Deferred Submittal Requirements and Application

PROJECT: Foster Bldg14

RE: 2829964
2829964 - Habitat for Humanity - Building 6,7,8,14

☐	APPROVED
☒	APPROVED AS CORRECTED
☐	REVISE AND RESUBMIT
☐	FOR YOUR INFORMATION AND USE
☐	INCOMPLETE SUBMITTAL
☐	NOT APPROVED

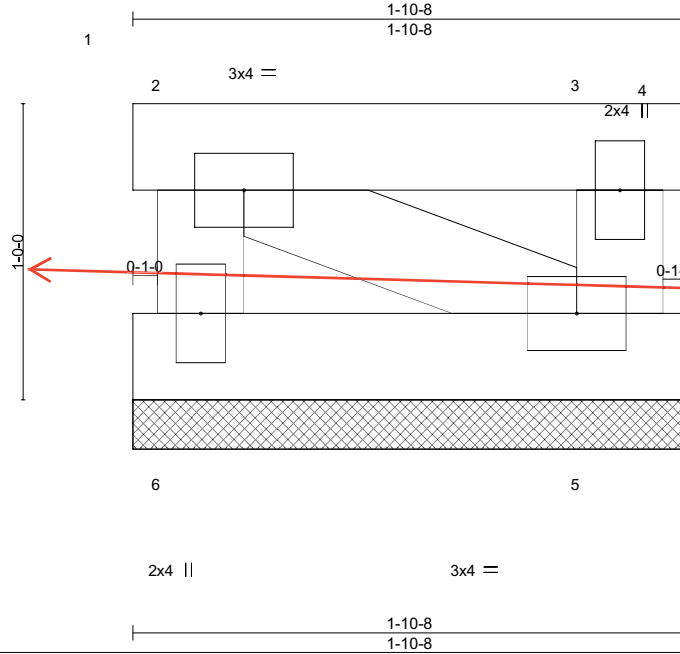
ARCH: PLS.
VERIFY: BLOCKING
SHOULD BE 11"
TALL TO ALLOW
FOR 1" COR-A-
VENT

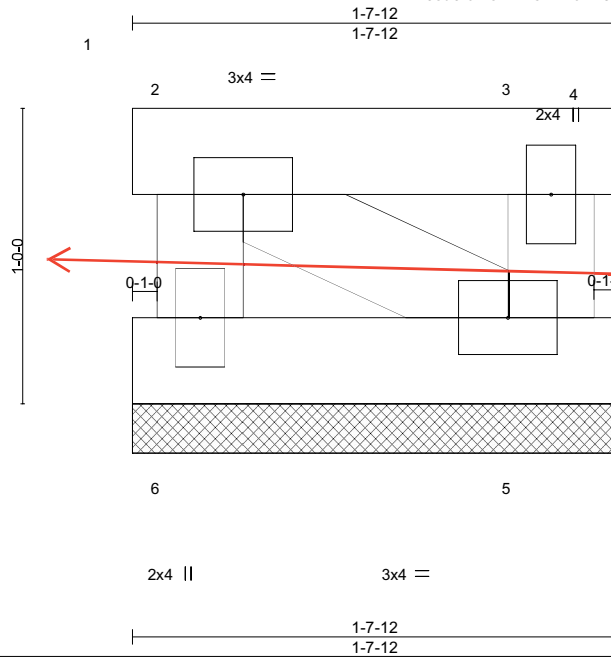
ARCH: PLS.
VERIFY: BLOCKING
SHOULD BE 11"
TALL TO ALLOW
FOR 1" COR-A-
VENT

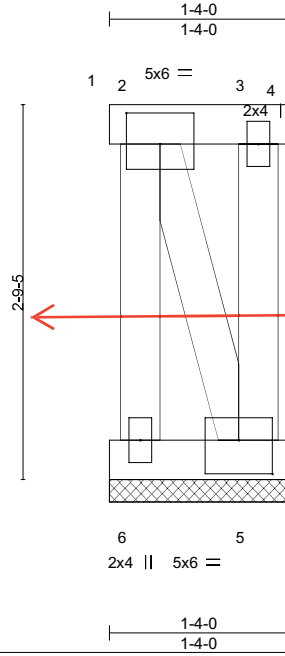
ARCH: PLS.
VERIFY: BLOCKING
SHOULD BE 2'-8
5/8" TALL TO
ALLOW FOR 1"
COR-A-VENT

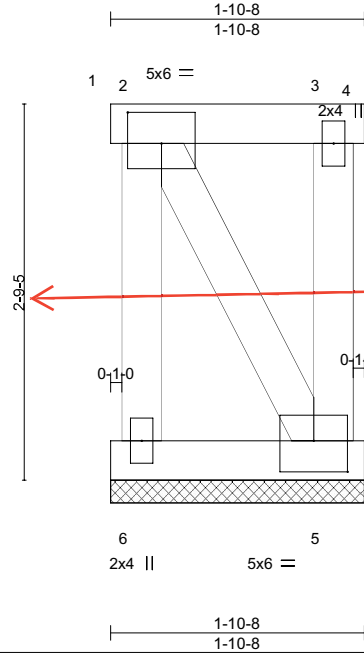
ARCH: PLS.
VERIFY: BLOCKING
SHOULD BE 2'-8
5/8" TALL TO
ALLOW FOR 1"
COR-A-VENT

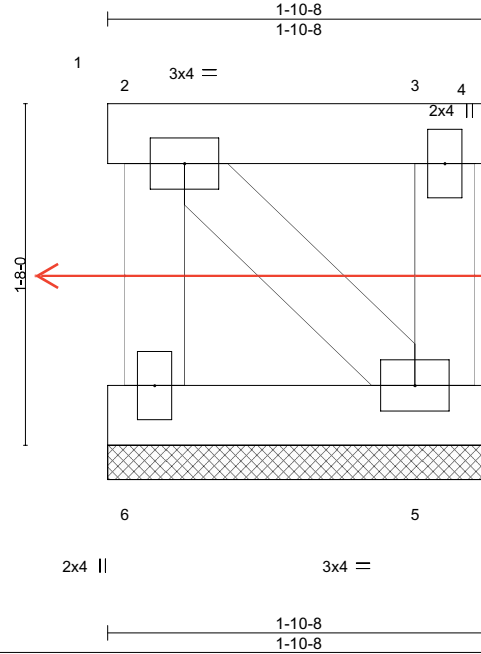
ARCH: PLS.
VERIFY: BLOCKING
SHOULD BE 1'-7"
TALL TO ALLOW
FOR 1" COR-A-
VENT

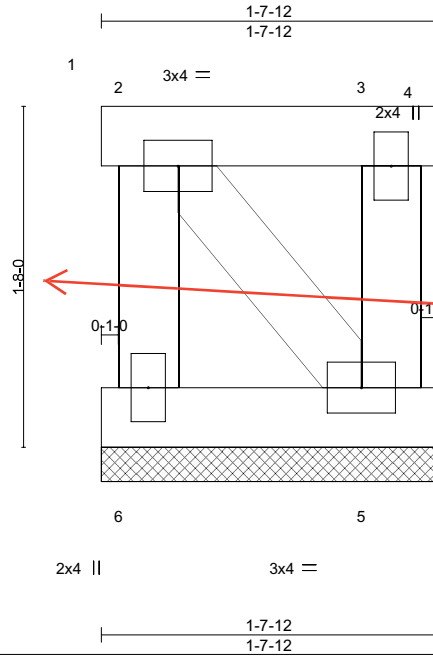
ARCH: PLS.
VERIFY: BLOCKING
SHOULD BE 1'-7"
TALL TO ALLOW
FOR 1" COR-A-
VENT

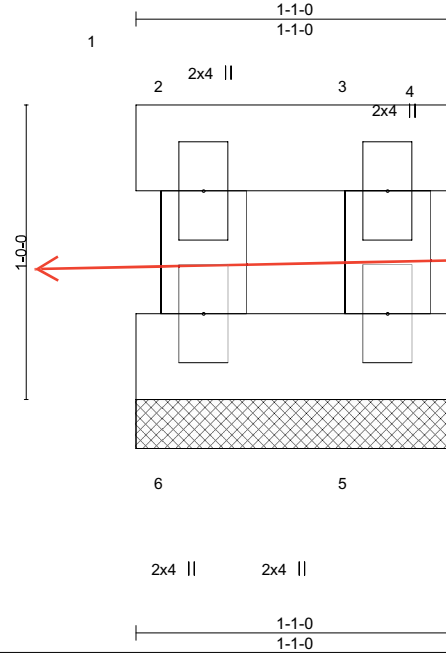
ARCH: PLS.
VERIFY: BLOCKING
SHOULD BE 11"
TALL TO ALLOW
FOR 1" COR-A-
VENT
